A High Resolution Global Scale Groundwater Model

Response to review

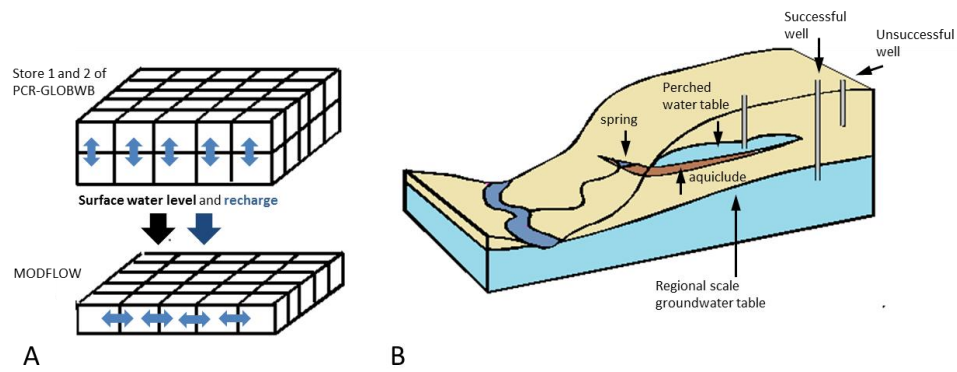
Clarification for some methods is required. Referring to the figures in the methods section and possibly including one or two small additional explanatory figures would help a great deal.

- As mentioned earlier, we clarified the methods according to the comments and included an additional figure explaining the model concept (Figure 1). This figure supports the explanation of the difference between the simulated regional scale groundwater levels and (likely) sampled perched water tables. This figure also helps to understand the results of the groundwater head comparison.
